PRODUCT CHANGE | Crown & Drive for 28mm Motor in 1.5" Tube

DISCONTINUED PRODUCT	REPLACEMENT PRODUCT	CHANGES MADE	
			YES	NO
DESCRIPTION.	"CROWN & DRIVE 28MM MOTOR IN 1.5"" TUBE with clip"	"CROWN & DRIVE 28MM MOTOR IN 1.5"" TUBE with clip"	<input type="checkbox"/>	<input checked="" type="checkbox"/>
CODE.	MT03-0110-069002	MT03-0110-069002	<input type="checkbox"/>	<input checked="" type="checkbox"/>
PACK SIZE.	10 250 EA	10 250 EA	<input type="checkbox"/>	<input checked="" type="checkbox"/>
COLOUR / FINISH.	White - 069	White - 069	<input type="checkbox"/>	<input checked="" type="checkbox"/>
IMAGE.			<input checked="" type="checkbox"/>	<input type="checkbox"/>
USE WITH.	2.0Nm Motor (28mm)	2.0Nm Motor (28mm)	<input type="checkbox"/>	<input checked="" type="checkbox"/>
TRANSITIONING.	November 2024

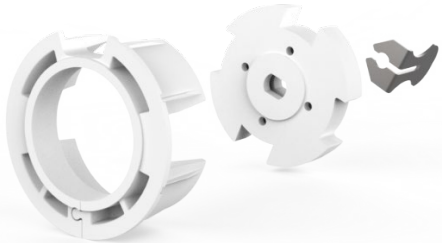
- No change in compatibility with Rollease Acmeda 1.5" Tube (RTEA#XX)
- Added compatibility with Louvolite Tube

- Tighten grip within Louvolite Tube on the Drive

- Added keyways on both sides of Crown.
